From: Price, John E
Sent: Friday, July 29, 2011 2:46 PM
To: 'Tai, Tom'
Cc: 'Brian.Thomas@nrc.gov'; Chakrabarti, Samir; Chakravorty, Manas; Head, Scott
Subject: Section 3.7 & 3.8 Actions - Updated July 28, 2011

Punch List for South Texas Project Units 3 & 4
Sections 3.7 & 3.8

**South Texas Project Units 3 & 4
Clarifications from NRC**

Issue 8: [Received 04/04/2011] (Audit Action Item 3.7-33 and 35) Stability Analysis Procedure

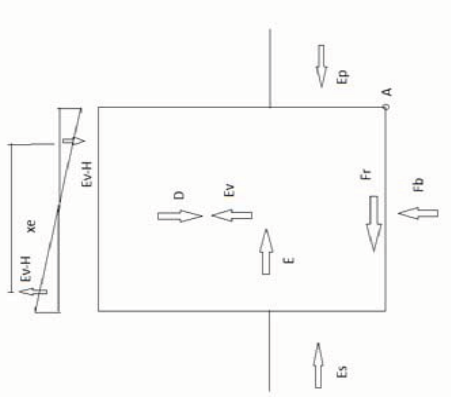
A brief presentation of the stability analysis procedure was made by the applicant during the March 14, 2011 audit. The presentation included a rigid body diagram showing the forces acting on the structure for stability calculations. The applicant indicated that the total seismic demand is calculated by summing all the inertia forces and moments acting on the structure. These inertia forces are calculated by multiplying the mass of each node by the absolute value of the maximum acceleration response at that node obtained from the SSI analysis.

The calculation of the seismic overturning moment is based on the horizontal seismic load E and vertical seismic load E_v about tipping point A , as shown in the figure below. The moment due to horizontal earthquake does not include E_v-H (vertical force due to horizontal input) which also produces overturning moment about A . The applicant is requested to provide justification for not including the vertical component of response due to horizontal seismic input in calculating the foundation overturning moment.
